Office Action Summary	Application No. 10/735,440	Applicant(s) KOLLMANN ET AL.	
	Examiner Charles E. Phillips	Art Unit 3751

APPLICATION NO.	FILED/RECEIVING DATE	FIRST NAMED INVENTOR	ATTORNEY DOCKET NO.	CONFIRMATION NO.
10/735,440	12/12/2003	Fabian Kollmann	3201-366 (D4700-00380)	2028
7590 STEPHAN P. GRIBOK DUANE MORRIS LLP ONE LIBERTY PLACE PHILADELPHIA, PA 19103		11/15/2007	EXAMINER PHILLIPS, CHARLES E	
			ART UNIT 3751	PAPER NUMBER
			MAIL DATE 11/15/2007	DELIVERY MODE PAPER

SN 10/735,440
Substitute Drawing

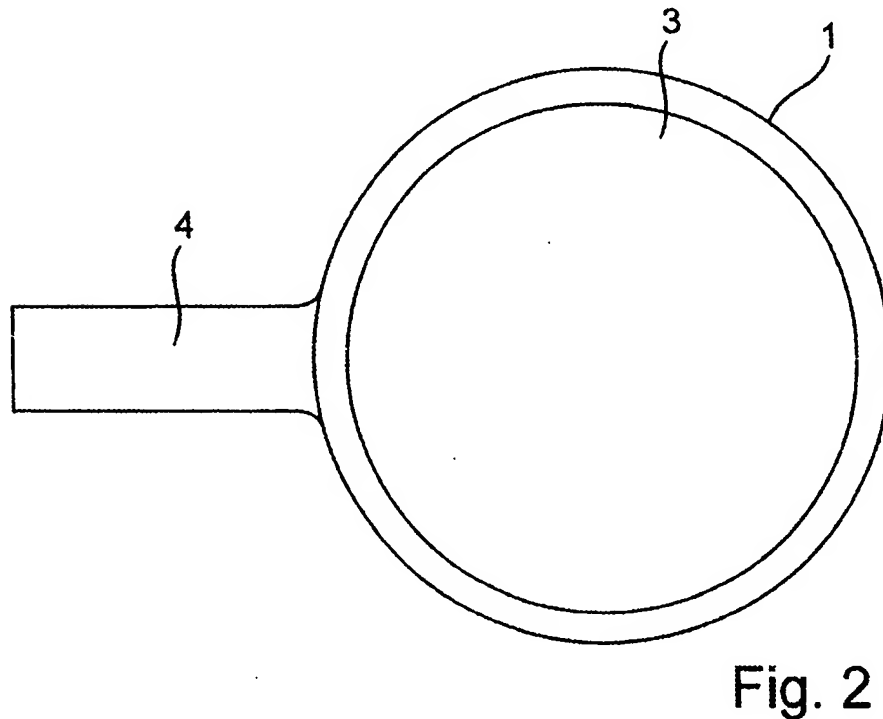
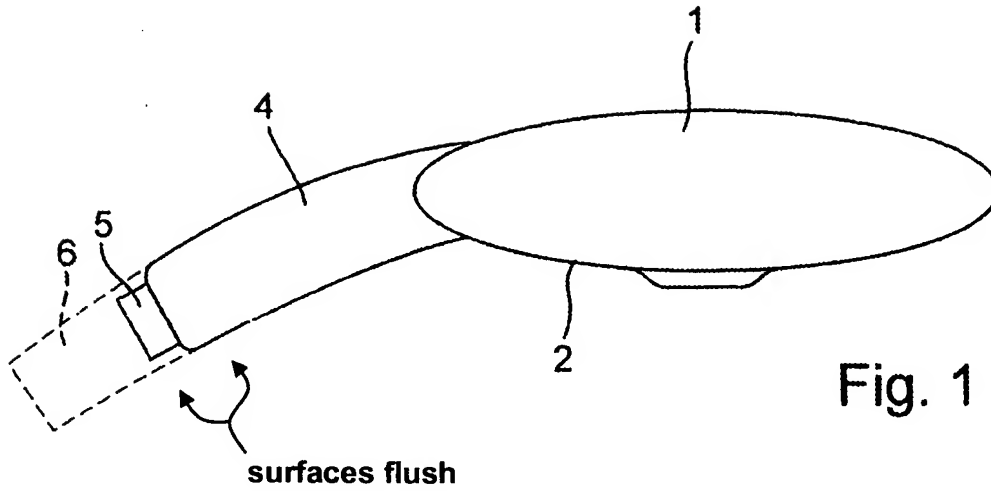
The proposed drawing correction filed on 9/28/07 is disapproved as the depiction of the union nut is inconsistent with that of the original drawings in that the double lines at the hose end are lacking, the fitting is of a different shape and the terminal end of the handle is rounded.

The drawings are objected to as being informal and for the use of a broken line showing of substance being claimed, i.e. under 37 C.F.R. 1.84(a)(4) broken lines are reserved for "alternate views". Corrected drawing sheets in compliance with 37 CFR 1.121(d) are required in reply to the Office action to avoid abandonment of the application. Any amended replacement drawing sheet should include all of the figures appearing on the immediate prior version of the sheet, even if only one figure is being

not approved
11/9/07 CEP
